Keithley Instruments  
28775 Aurora Road  
Cleveland, Ohio 44139  
1-800-833-9200  
[tek.com/keithley](http://tek.com/keithley)

Model 2450 Interactive SourceMeter® Instrument, 2450-NFP, 2450-RACK, 2450-NFP-RACK

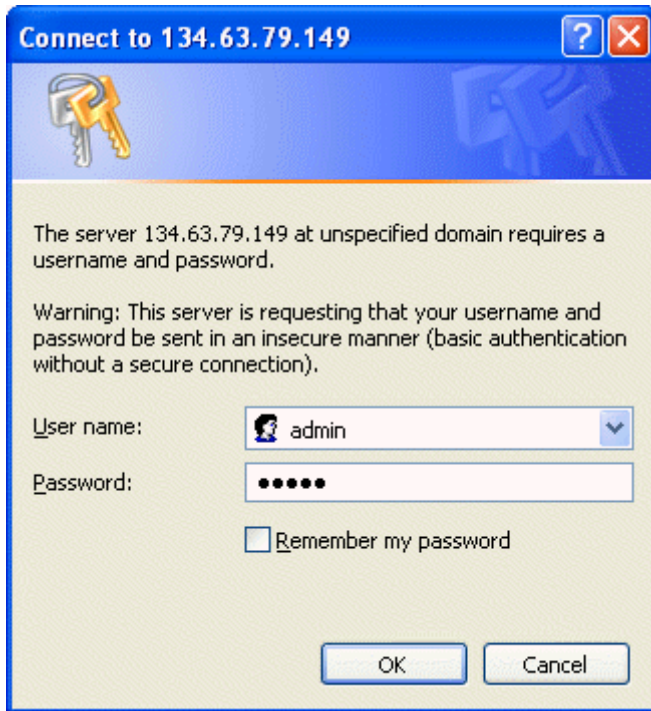
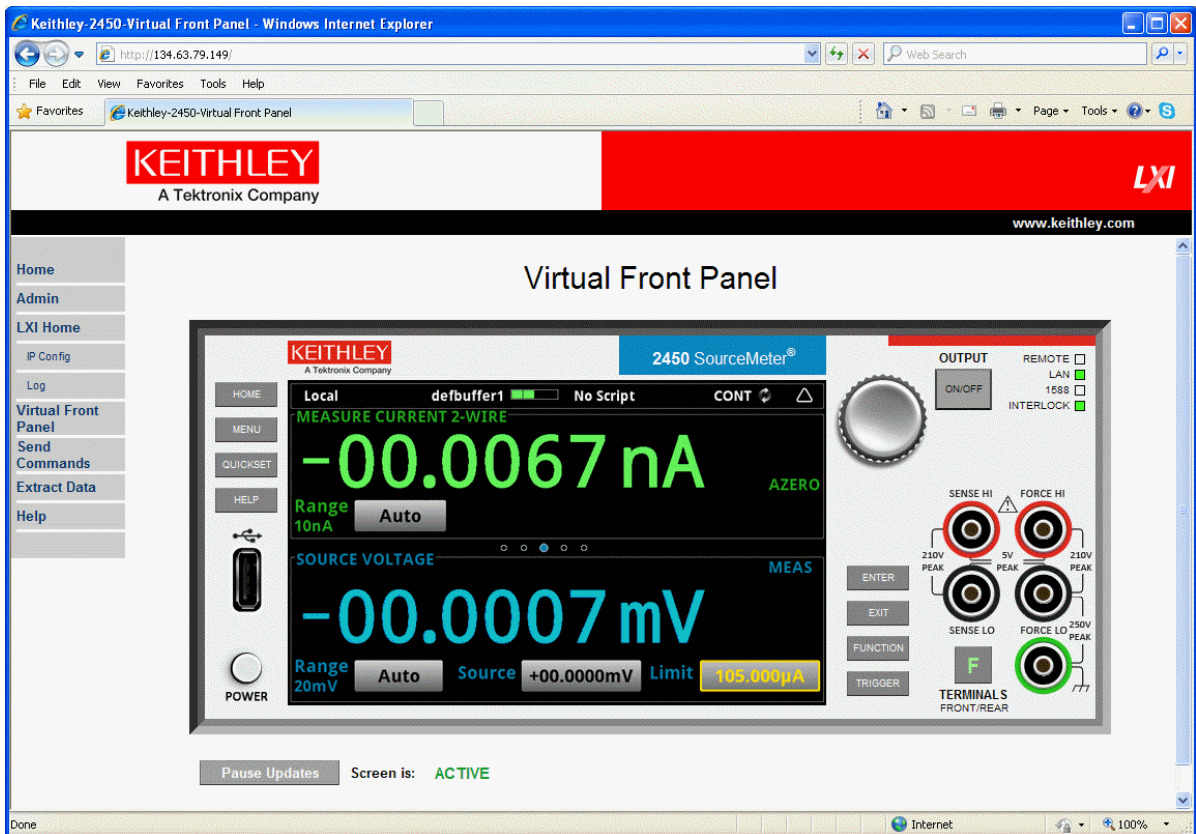
Implement new Virtual Front Panel capability.

To access the new Virtual Front Panel, access the 2450 through Ethernet using your favorite Internet browser.

When asked for a Username and Password: enter the Username and Password for that particular 2450. The default Username is `admin` and the default Password is `admin`.

An example of the 2450 Virtual Front Panel is shown below. Users can use their mouse from a standard PC to control the instrument. Users can also use touch screens from most touch screen devices that can access the 2450 IP address.

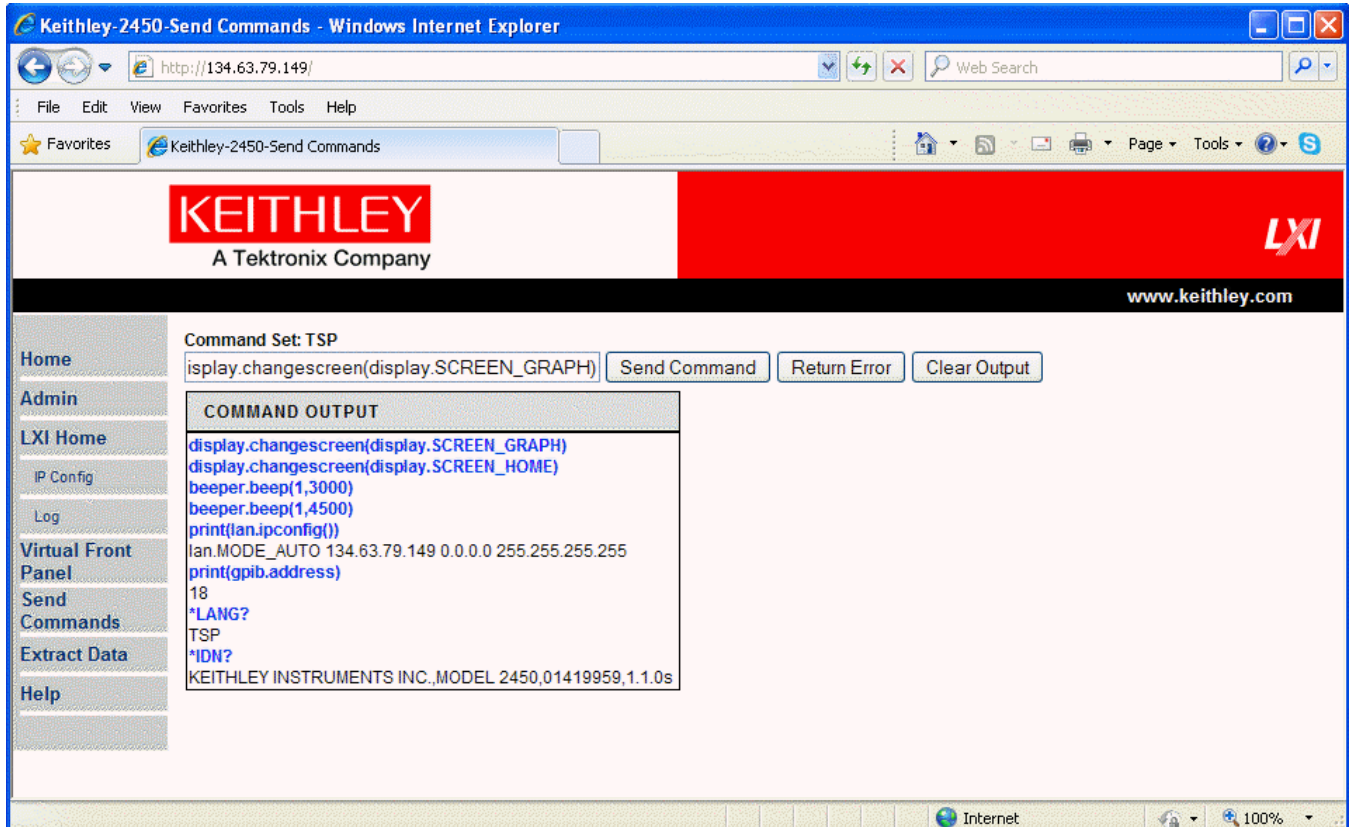
The behavior of the \*LANG? command on the 2450 has been changed as follows.

Sending the query \*LANG? over a non-controlling interface will no longer change the interface control of the unit. For example, if the unit is under local control, then sending the \*LANG? over Telnet, USB, or GPIB will leave the unit under local control. This was done in order for KickStart (or any other remote control software) to query connected/accessible instruments without resetting them or changing or disturbing the current trigger model.

SVMR

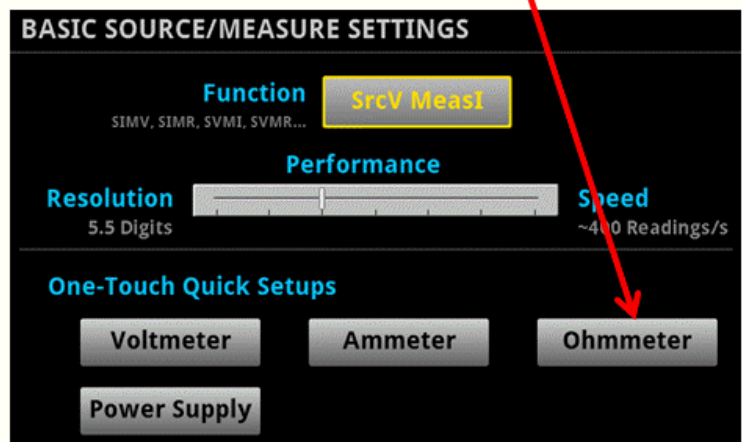
- g. New SCPI Command Usage:
  - i. "Manual Ohms" (see definition above)
    - SOURce:FUNC VOLTage
    - [SENSe[1]]:FUNC "CURRent"
    - [SENSe[1]]:CURRent:UNIT OHMOR
    - SOURce:FUNC CURRent
    - [SENSe[1]]:FUNC "VOLTage"
    - [SENSe[1]]:VOLTage:UNIT OHM
  - ii. "Auto Ohms" (see definition above)
    - [SENSe[1]]:FUNC "RESistance"
- h. Front panel user interface setting of Manual vs. Auto Ohms measurements  
<see the following figure for details>

Both exhibit "Manual" Ohms behavior (works just like Power by setting units to Ohms and going to SVMI or SIMV)

Exhibits "Auto" Ohms behavior
